**City of Kingston
Information Report to Council
Report Number 19-115**

To: Mayor and Members of Council
From: Lanie Hurdle, Acting Chief Administrative Officer
Resource Staff: Paige Agnew, Director, Planning, Building & Licensing Services
Date of Meeting: April 16, 2019
Subject: 5 Lower Union Street & 55 Ontario Street – Ongoing Appeal of Applications for an Official Plan & Zoning By-Law Amendment
File Number D35-003-2017, LPAT Case Number PL180379

Exhibit F Heritage & Urban Design Peer Review Comments Prepared by Dillon, Provided to the Applicant on March 6, 2018

Figure 4: Image showing the proposed heights of the proposal and car parking podium (Source: Hannah, Ghobrial and Associates LTD)

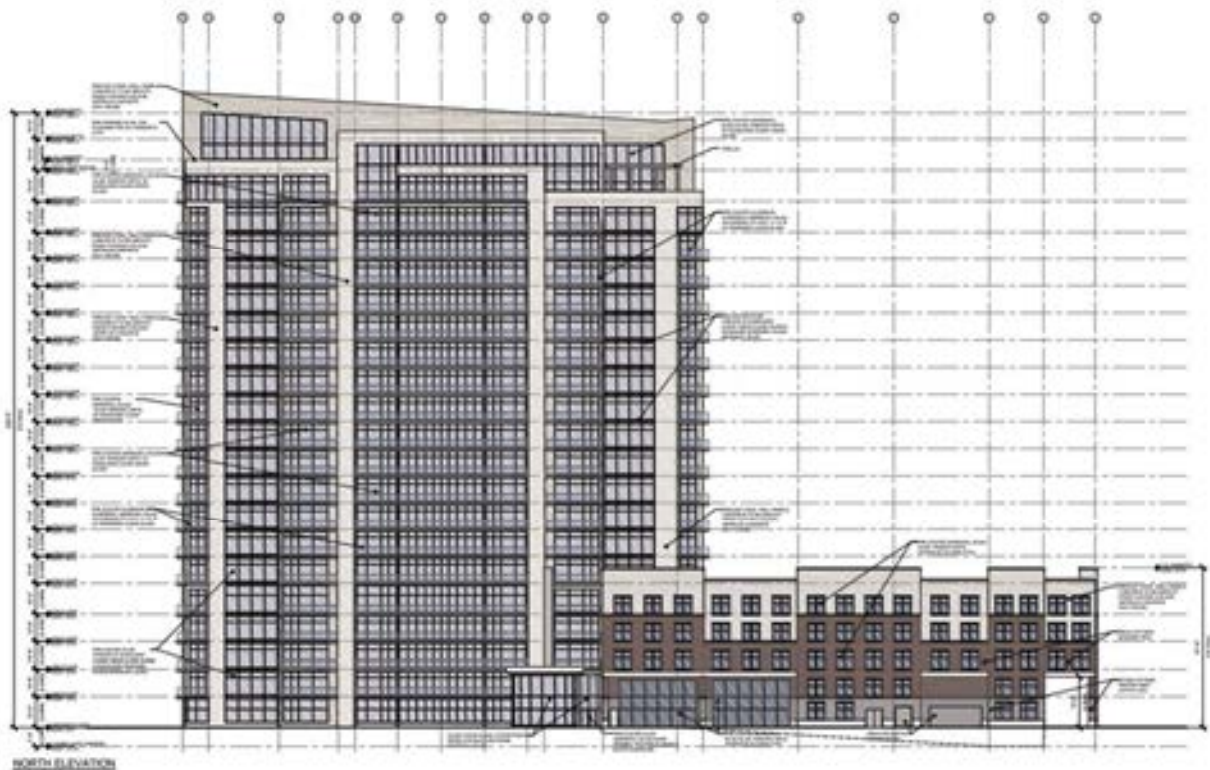
Building height is discussed in more detail in the ZBL. The ZBL for the subject site states that in a HR zone, buildings shall be no taller than 2 stories or to not exceed 10.7m (Section 9.2). The proposal at a height of 72.54m far exceeds the height of 10.7m as stipulated in the ZBL.

Figure 4 illustrates the large scale of the proposal. While there is an emerging built form along the waterfront, new development should have a minimal impact on surrounding areas.

Figure 5: Shadow analysis showing the summer and winter solstice and equinox (Source: HGA Limited)

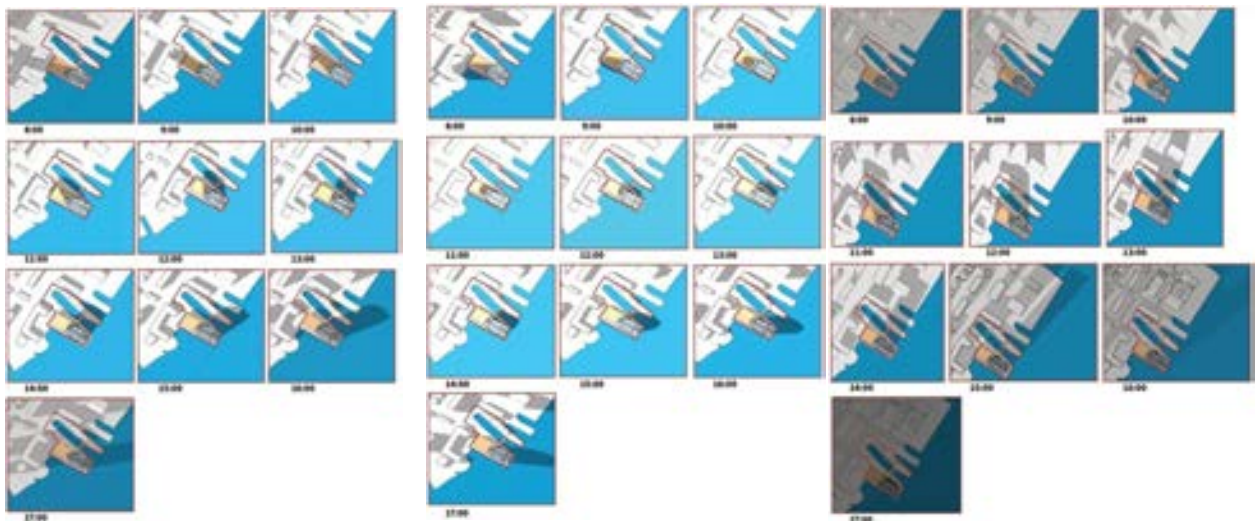
Figure 5 shows the different shadow analysis results for the proposal during the spring, summer, fall and winter. During the summer solstice, the proposal casts a shadow within the open space area of 33 Ontario Street in the early morning. Until 3pm, the 20 storey building’s shadow is contained within its own footprint, with shadowing occurring on the north eastern wharf at 3pm. This is only minor however and after 5pm, the entire shadow of the building is cast over Lake Ontario. During the Spring and Fall equinox the proposal casts a larger shadow over 33 Ontario Street but after 10pm, the shadow is cast over the Dry Dock and the eastern end of the Pump House. This means any future residential units in the Pump House complex will not be affected, nor will the open space area in the north western end of the Dry Dock. The north eastern wharf is overshadowed entirely from 2pm onwards, but there is no significant impact on any built form here.

The winter solstice creates a larger shadow yet this predominantly affects the area behind the Pump House. Between 10am and 3pm, the building’s shadow moves across the Dry Dock and overshadows part of 5 Gore Street.

Overall, despite the height of the building, it does not cause any significant overshadowing issues; however, this is because the building is sited at the easternmost edge of the development site.

Figure 8: Massing of proposed building in relation to other waterfront development (Source: HGA Limited)

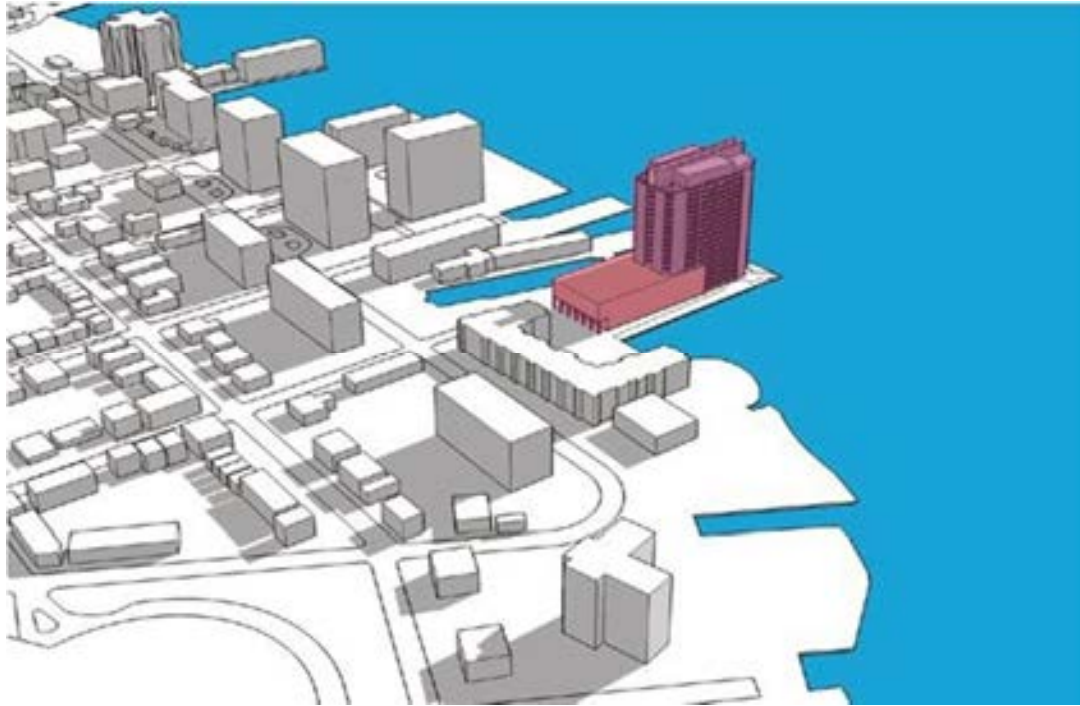
The Report states that it “maintains a mid-rise profile closest to Ontario Street, through the 5-storey parking podium” and that this “provides an appropriate massing transition between the low-rise Sydenham neighbourhood to the west and the high-rise tower along Lake Ontario to the east.” Figure 8 demonstrates how the parking podium is actually lower than the neighbouring building and therefore does not aid in a transition of heights between the neighbouring building and the tower when viewed from the west. This does not therefore comply with section 2.7.6 of the OP as outlined above. The Report further states that “the proposed tower is not out of keeping with the character of existing built form along Kingston’s waterfront.” While this is the case as shown in Figure 8, it does not meet the guidelines regarding building massing in the OP (section 2.7.3 and 2.7.6) nor the Design Guidelines for Residential Lots, which call for a transition in heights through a series of setbacks.

Further, the massing of the building is exaggerated as the ground floor has no visual interest and provides a blank wall along the western façade. As there is no visual interest or activity provided, the proposal appears larger from street level as it is not broken up. The first floor needs to incorporate visual interest, avoid blank walls, and consider incorporating uses that encourage activity, such as mixed use.

This is further exaggerated by the lack of relationship between the podium and the tower, which appear as two disparate building forms rather than one cohesive development. This serves to make the tower appear larger as there is no true tower-podium relationship. Notably, the podium should not stop where it meets the tower but continue to wrap around the entire base of the proposal with the tower stepped back above it from all sides.

- Wrap the podium of the building around the entire base of the building to create a better relationship between the podium and the tower;
- Provide stepbacks to reduce the building massing and create transitions in height; Setback the proposal further from the water's edge on the northern side to meet the 10m setback requirement;

Figure 9: Waterfront walkways (Source: ERA Architects)

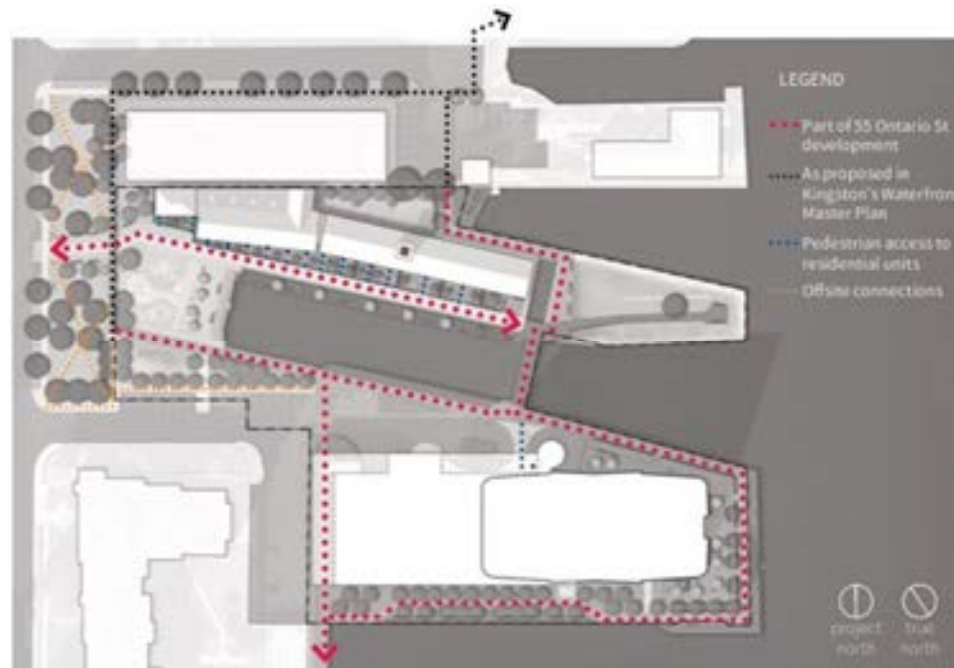
The proposal has walkways which go around the perimeter of the site, as shown in Figure 9. The conceptual landscape plan referenced in the Report discusses the waterfront trail and states that it reinforces the waterfront. While the incorporation of the walkway into the site responds to the direction of the OP and also serves to vitalise waterfront areas, the walkway does not meet the width standards as stipulated in the ZBL, as it is not 10m wide. However, the landscaping around the pathway could be included as being a part of the overall walkway if it is publicly accessible. This is the case for the southern side of the proposal, but the eastern and northern side have private amenity areas which are on the outside of the building. In these areas, the private area does not count as a part of the walkway and therefore the proposal does not meet the minimum width requirements for waterfront walkways as stated in ZBL Section 9.2.2.1.

With regards to the setback requirements, the proposal is setback 10m from the water’s edge on the southern and eastern side, but it is only 6m at its narrowest point on the northern side. The Report states this is due to the natural confinement of the site and that if it were 10m on the northern side, the proposed building would have an irregular shape. The proposal is therefore not compliant with 9.2.1 of the ZBL.

The proposed building footprint needs to be modified so it provides a 10m, publicly accessible buffer around the building to ensure compliance with the 10m setback from the water's edge and provide a 10m public walkway.

Figure 10: Ground floor floorplan showing amenity area (Source: Hanna, Ghobrial and Associated LTD)

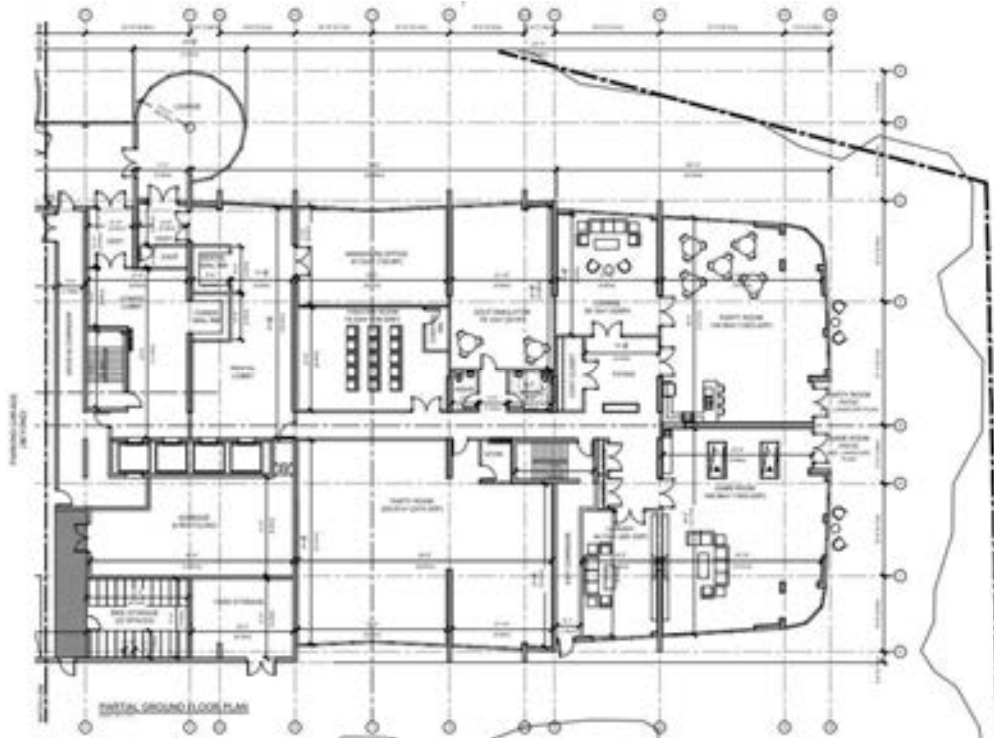
The proposal provides 4,613.78m² of amenity space. This is in the form of a series of dedicated amenity spaces on the ground floor. There is space set aside for potential game rooms, party rooms, library, theatres and lounges, as well as some private patios, as shown on Figure 10. There is also space identified on the 20th floor where there are additional party rooms, a library, games room, a lounge and 2 terraces.

While the current proposal can be commended for providing 1,693.78m² more amenity space than would be required, this has an impact on the building's footprint and resultant urban design since much of the amenity space is located at the ground floor, and the tower follows the building line from the ground floor up. This is a particular concern because the position of the building on the site, as well as the placement and amount of amenity space, contribute to the building's encroachment into the 10m waterfront trail and 10m setback from the water's edge.

In addition, section 5.5.2 of the ZBL has communal amenity area size requirements. It states that “if provided as communal space, (amenity areas) must be aggregated into one area or grouped into areas of not less than 54.0 square metres.” The proposal meets these requirements for all amenity spaces, apart from the library on the ground floor which is 44.74m², and it is anticipated that this will be resolved in the updated design addressing the above-noted issue with the building floorplate.

The amenity space provided should be reduced to aid in addressing the aforementioned issues with insufficient walkways and the building's floorplate/massing.

Figure 11: Proposed vehicle access through the Navy Memorial Park (Source: ERA Architects)

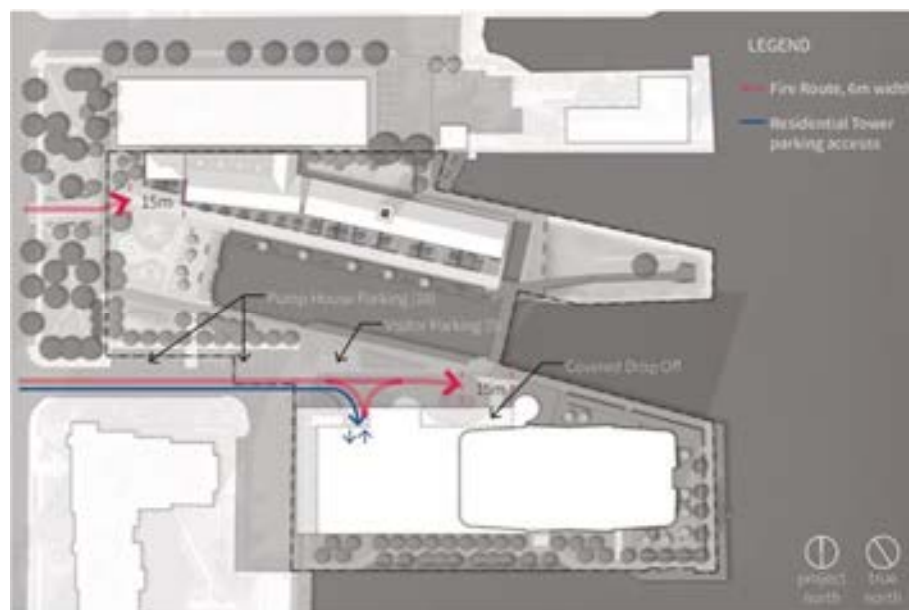
The Report proposes the creation of an access route through the existing Navy Memorial Park from Ontario Street, as shown in Figure 11. Section 3.2.3 of the Report states that the fire route through Navy Memorial Park will “feature a differentiated paving treatment to give it the appearance of a pedestrian plaza, thus deterring other vehicles from entering the site. Retractable decorative bollards (or similar) may also be used to control access.” The route is only 6m wide, and below the required 20m standard width for emergency vehicle access as stated in Section 4.6.22 of the OP.

It does not appear that there are extenuating circumstances that warrant the creation of an emergency access through Navy Memorial Park. The Pump House site can be accessed from Lower Union Street and it is common practice that the emergency route for a development be located on site. The Park should remain unaltered and the access route located in a way which does not impact the existing layout of the park.

Recommendations	<p>Access to the Pump House and Dry Dock area through Navy Memorial Park is proposed for this development. However, there are no extenuating circumstances that warrant an access driveway through the park. It is recommended that access be provided at another point of egress, and the following specific remedy be considered:</p> <ul style="list-style-type: none"> • Provide emergency access from Lower Union Street
